Petition Number: 2016-115

Transportation Summary

Rezoning Transportation Analysis Petition Number: 2016-115 General Location Identifier: 04742101, 04742102, 04742106

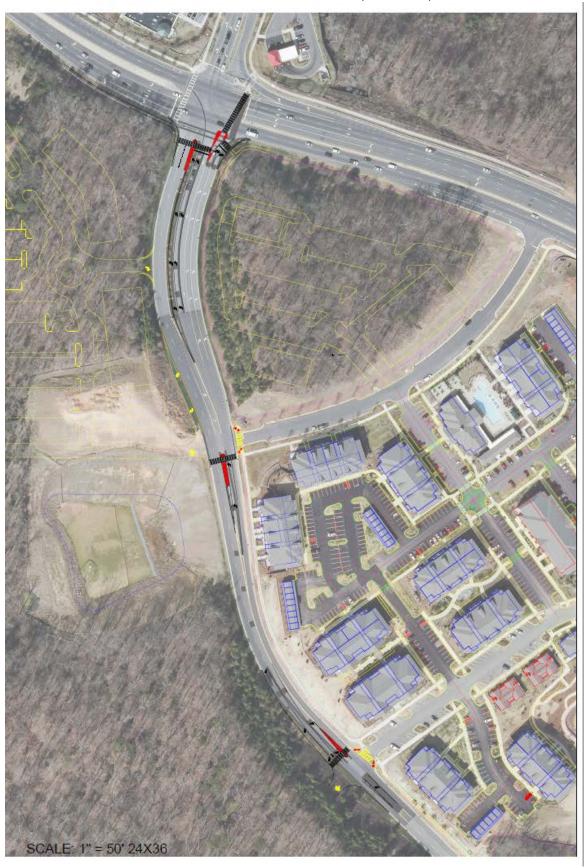
- a. An additional NB Senator Royall Dr. 200' left turn storage lane w/appropriate bay taper length at Mallard Creek Church Rd. (the existing Senator Royall Dr. median must remain 8' wide to provide adequate pedestrian refuge space) (see below exhibit).

- b. Channelized NB dual right turn lanes with protected traffic signal pedestrian phasing (see below exhibit).
 - <u>8/26/16 Update:</u> Revise note 4a to include this transportation improvement and remove from 4c (iii).

- c. Traffic signal modifications to accommodate the NB dual lefts and NB dual right turns on Senator Royall Dr. NB approach at Mallard Creek Church Rd. (see exhibits below). 8/26/16 Update: Revise note 4a to include this transportation improvement and remove from 4c (last sentence).

- 8. Include Parcel "C" Improvements The widening of Senator Royall Dr. includes an 8' raised landscaped median, and up to three (3) pedestrian refuge islands located at Alexander Village Main Dr., Heritage Pond Dr. and one to be determined during the construction permitting process (see below exhibit).
